*Global BioRID-II User's Meeting*

*Friday January 22, 2010*

# *Dummy Status*

T L F DUMMY LUMBAR SPINE MX LOAD CFC\_600

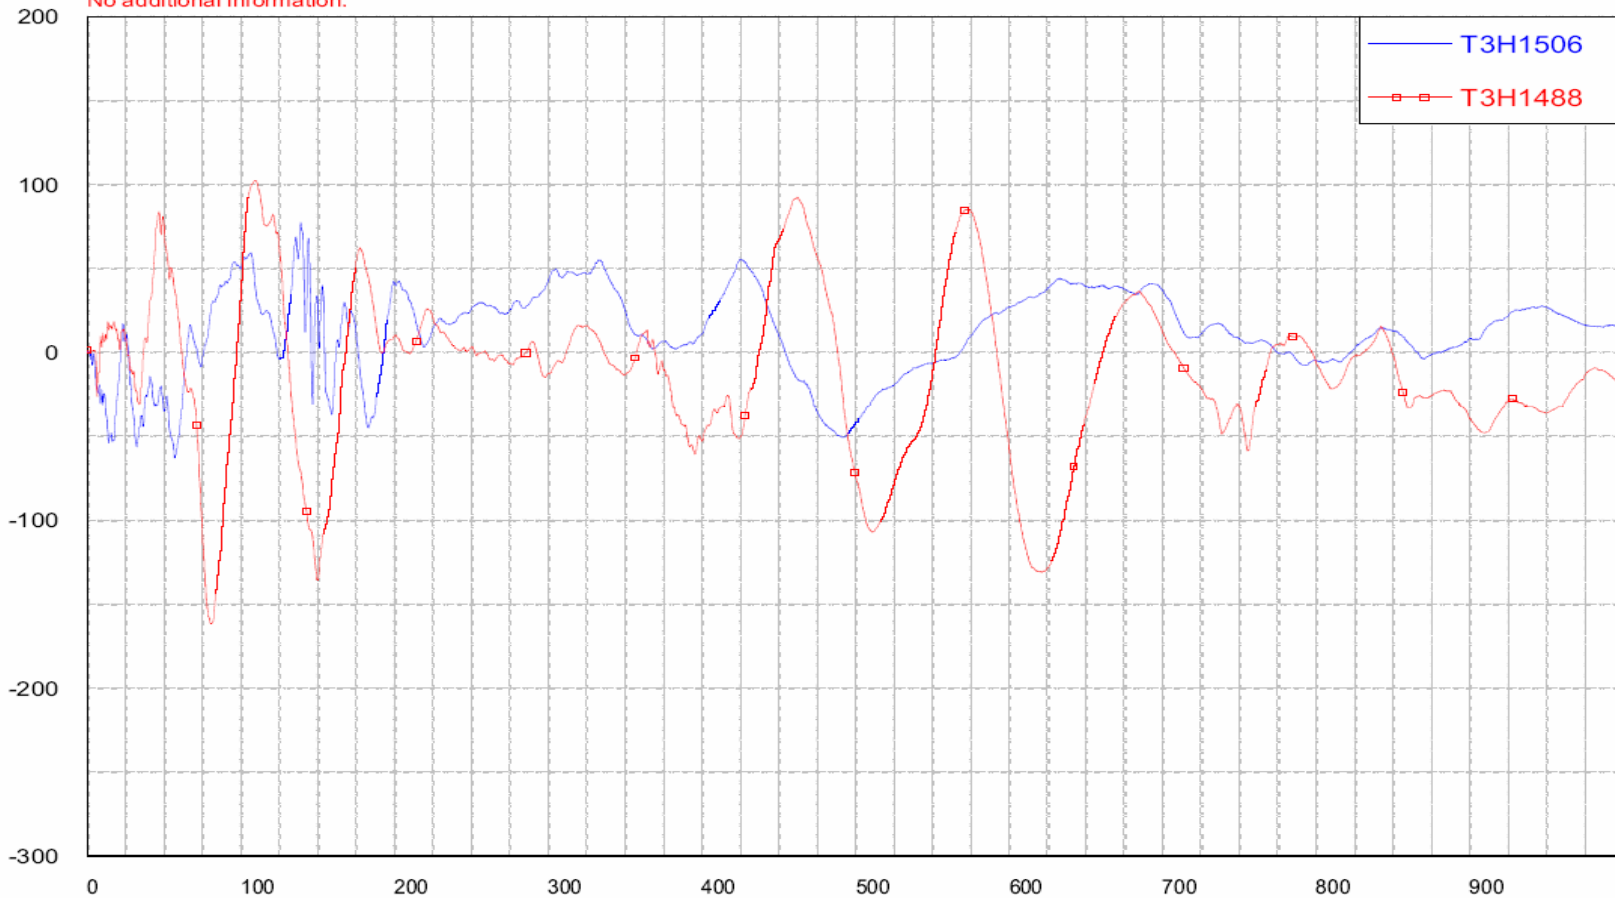
- *Lumbar Concern*
  - *The new test does not have a chest stop to decelerate the test - only at the sled. This causes larger forward torso rotation upon stopping than the old sled.*

- *We are concerned that the lumbar vertebrae pin holes may become damaged.*
  - *Data was collected to 1000 ms based on video showing rebound timing*

- *Lumbar Forces at the stop are still 3 times higher than what we see in vehicle.*
  - *Could this force cause the vertebral pin holes to oval over time, causing damage and failing dummy responses over time?*

- *Lumbar MY – pg 27*
  - *Upper Neck FX – pg 4*
  - *Upper Neck MY – pg 8*
  - *T1 FZ – pg 17*
  - *T1 MY – pg 18*
  - *Lumbar FX – pg 23*
  - *Lumbar MX – pg 26 – oscillation on new sled?*
